# PITT ST SOUTH

OVER STATION DEVELOPMENT

RESPONSE TO SUBMISSIONS

SEPTEMBER 2020

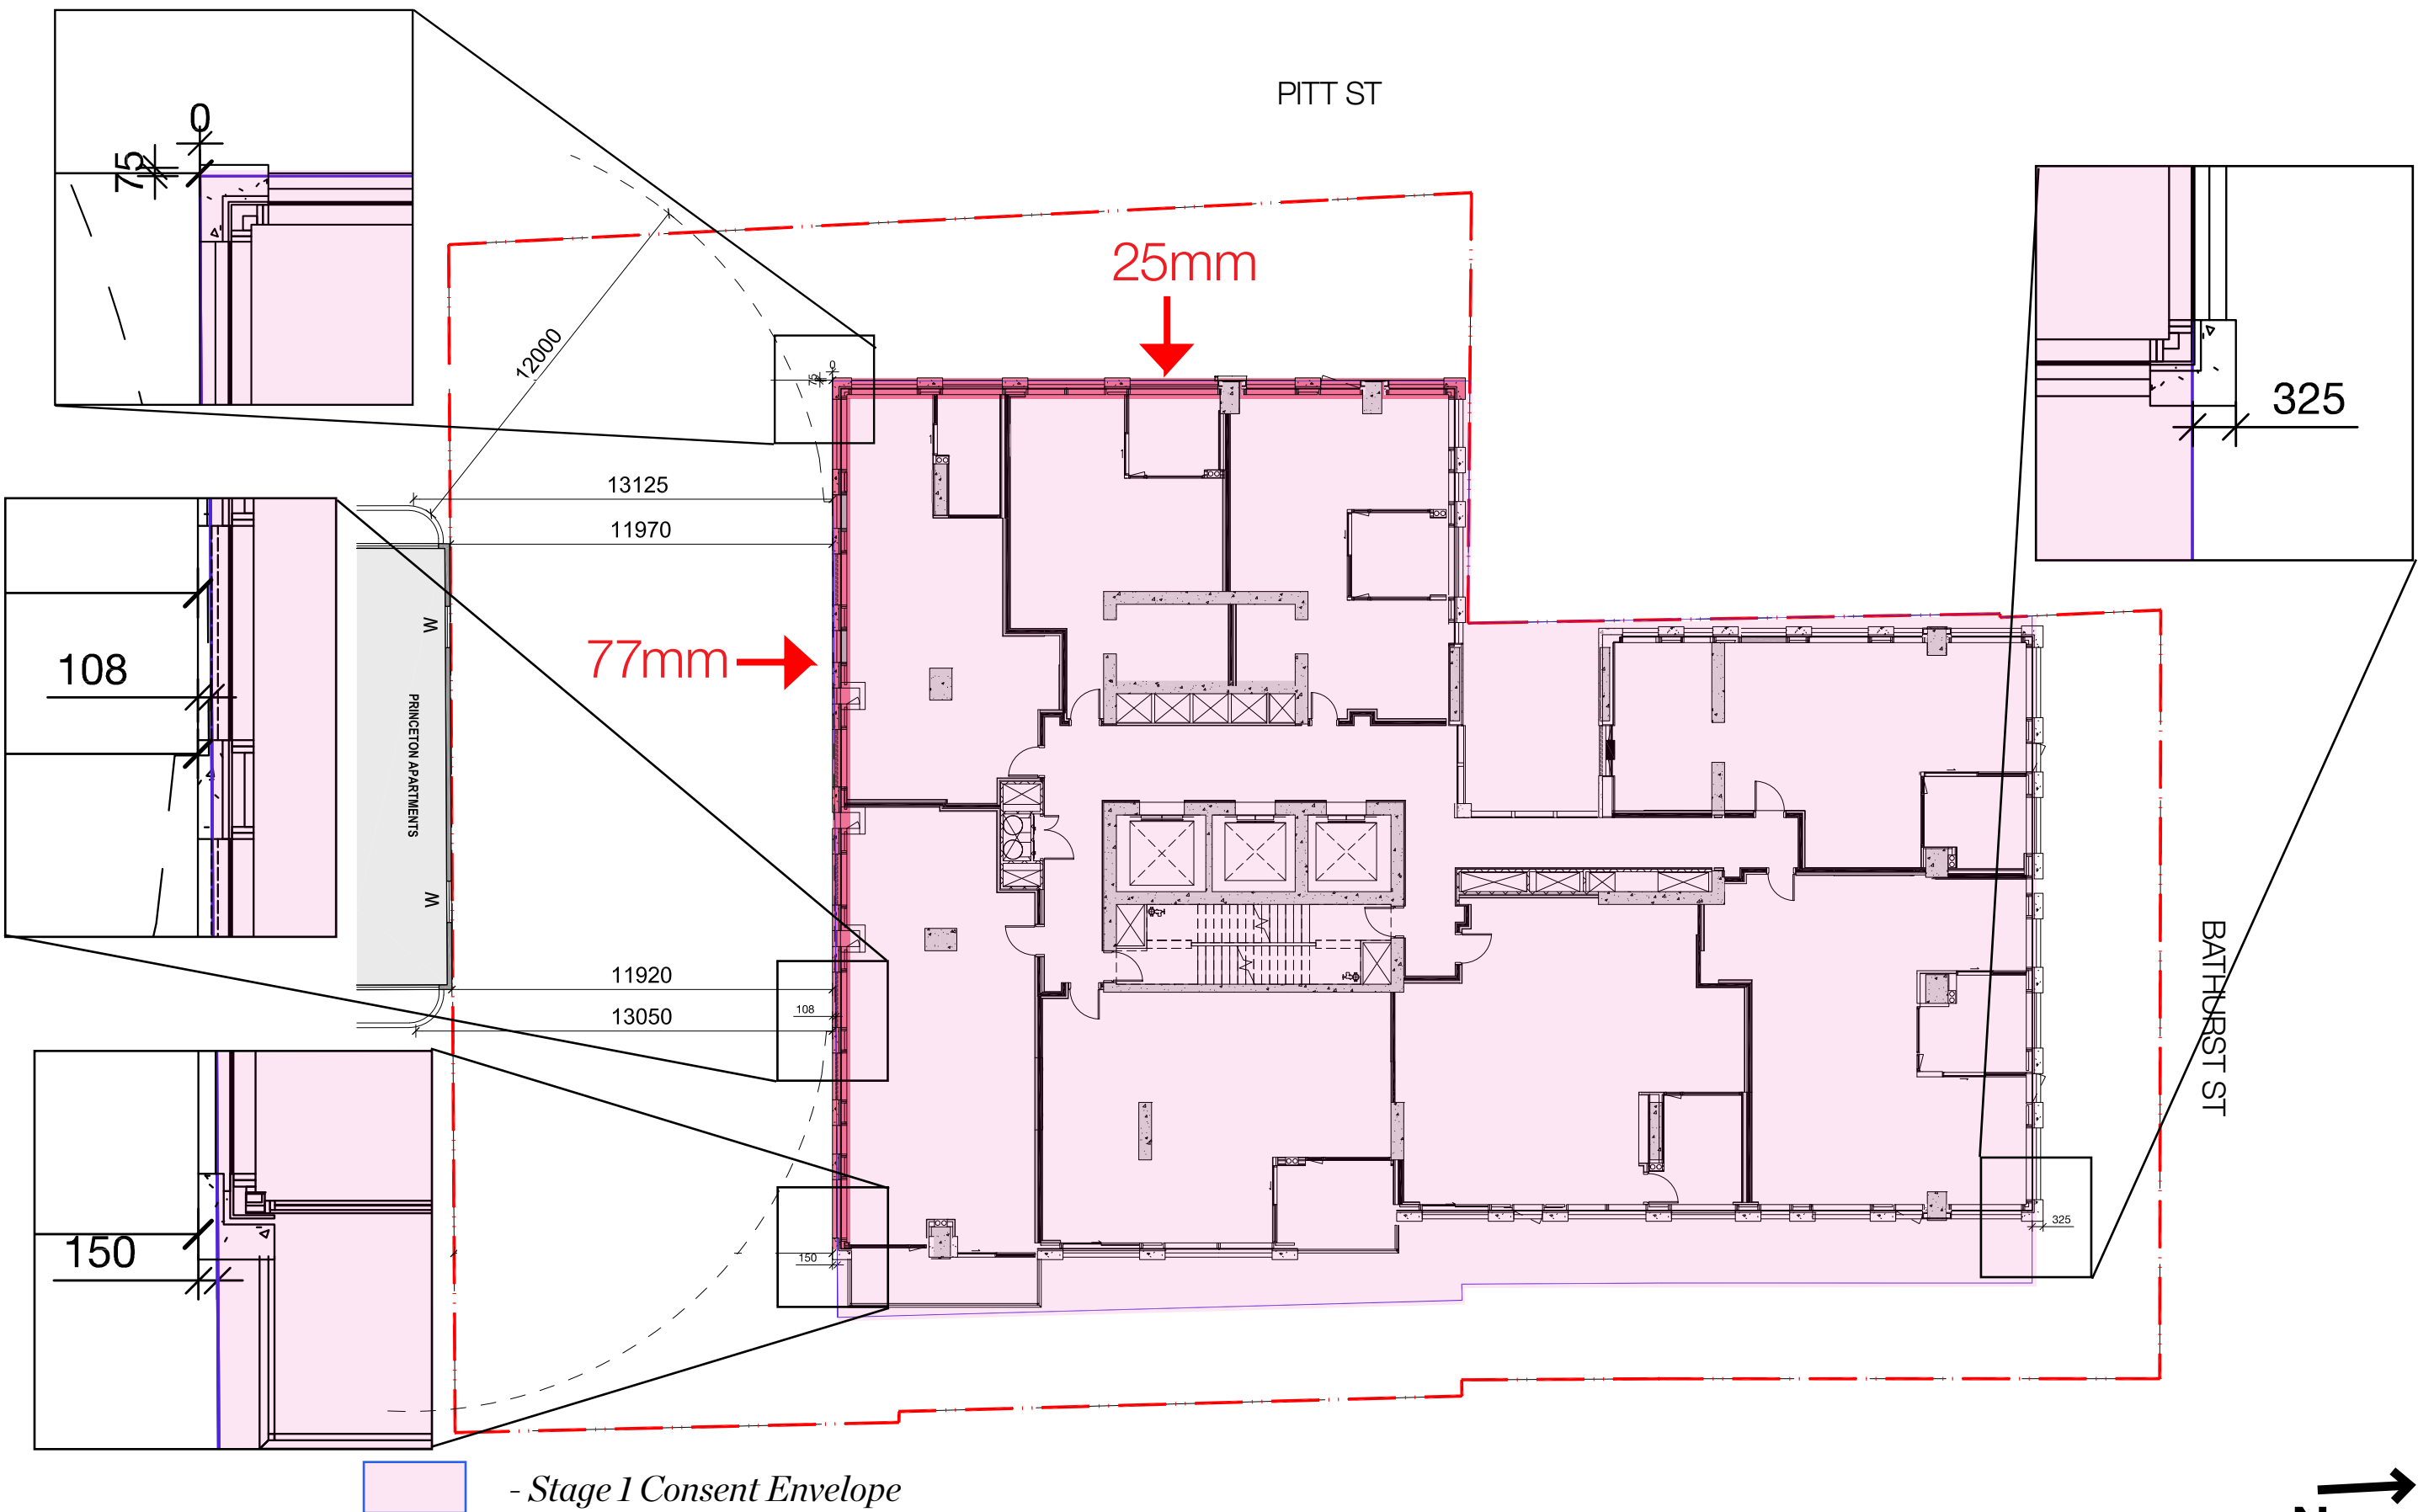
(c) Review the appropriateness of the proposed projections beyond the approved building envelope with respect to any additional impacts when compared to a complying development, including further consideration of any:

- \*overshadowing impacts to adjoining residential properties
- \*privacy and visual impacts resulting from further encroachments on minimum building separations
- \*streetscape impacts
- \*ongoing maintenance of boundary conditions.

In order to minimise overshadowing to Princeton (described in Section 1), the West, East, and North facades have been reduced in depth from 450mm to 325mm. The architectural methodology behind this change is described further in this section.

In addition, the West Facade glassline and perimeter columns have been moved 25mm East from the location proposed in the SSD DA, and the South Facade glassline has been pulled north by 77mm from the location proposed in the SSDA. These are the maximum adjustments that can be achieved:  
/ without substantial changes to columns which would cause an impact to the station beneath,  
/ without causing apartment or room dimensions to fall below ADG minimums.

The resultant proposed facade projections are shown on the adjacent drawing:

Level 06 Terrace\_SSDA\_Plan

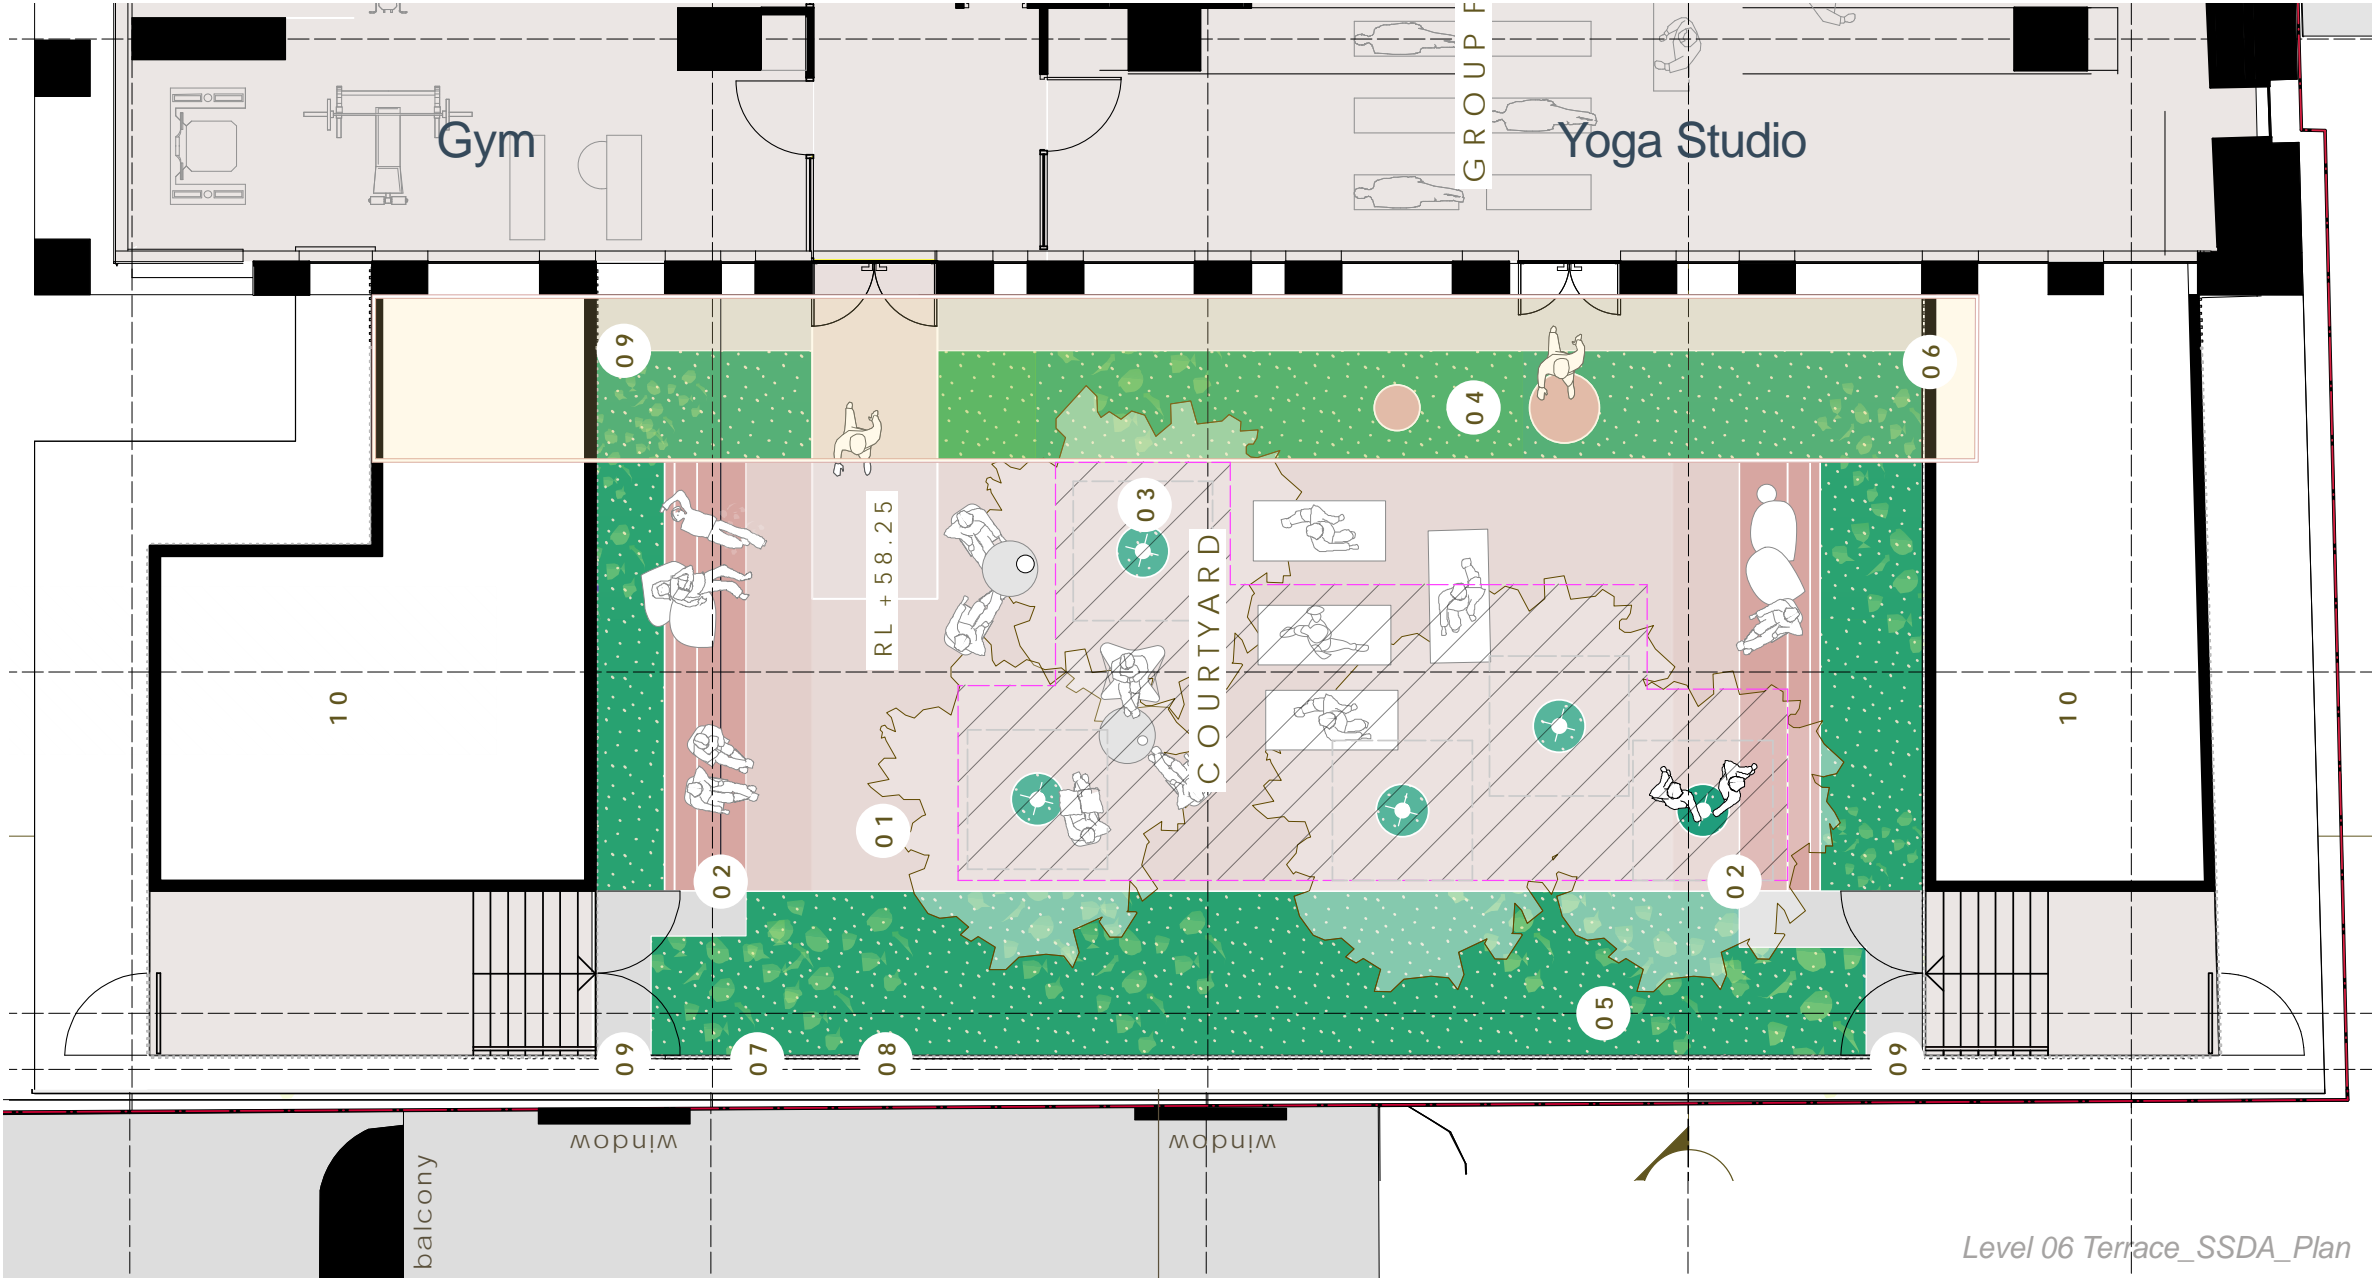
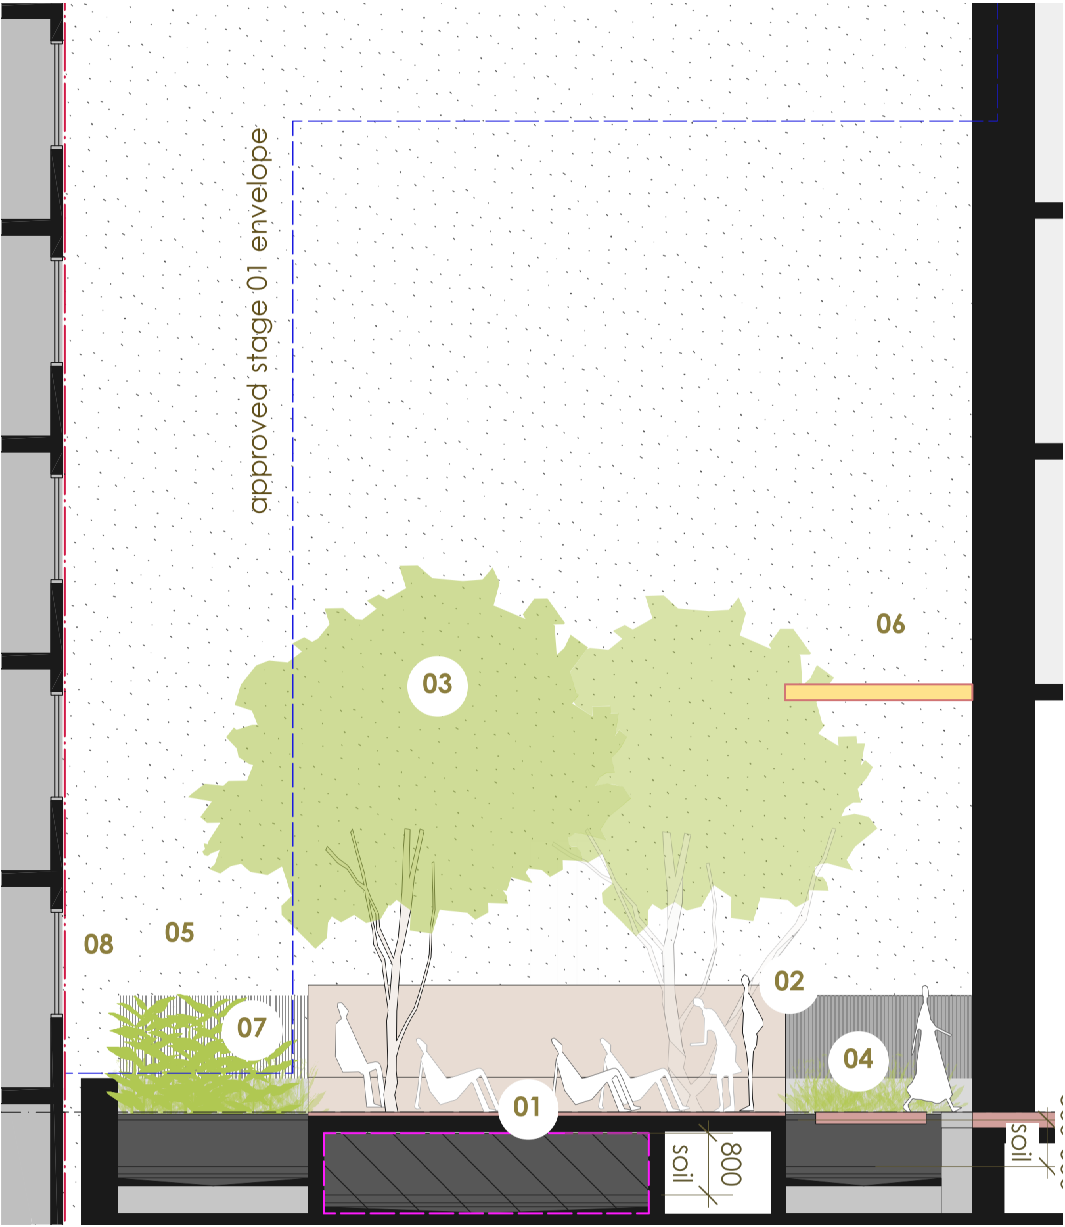
*(d) Demonstrate a reasonable level of privacy and amenity can be maintained between the proposed building and adjoining Princeton Apartments, including further consideration of:*

The adjacent drawings show the interface with Princeton Apartments as proposed in the SSD DA.

At level 06, a 207 sqm external landscaped communal open space was proposed spilling out from an indoor wellness centre. The internal wellness centre contains a 20m indoor pool, gym, and various yoga and amenity spaces for exclusive access to residents.

To the east and west of the external terrace, two partially recessed plant rooms rose a nominal 1.5m above terrace level, providing some protection from east / west winds and a comfortable sense of enclosure. These plant projections and surrounding privacy screen projected approx. 1 metre above the approved concept envelope in places, whilst a complying minimum of 3m was provided to the boundary of Princeton in accordance with the approved envelope. Screen planting was located along the southern edge of the terrace to provide a degree of visual privacy to low level windows on the boundary of Princeton apartments. The terrace received very little solar access during winter and was dependant on a canopy to protect against wind downdrafts.
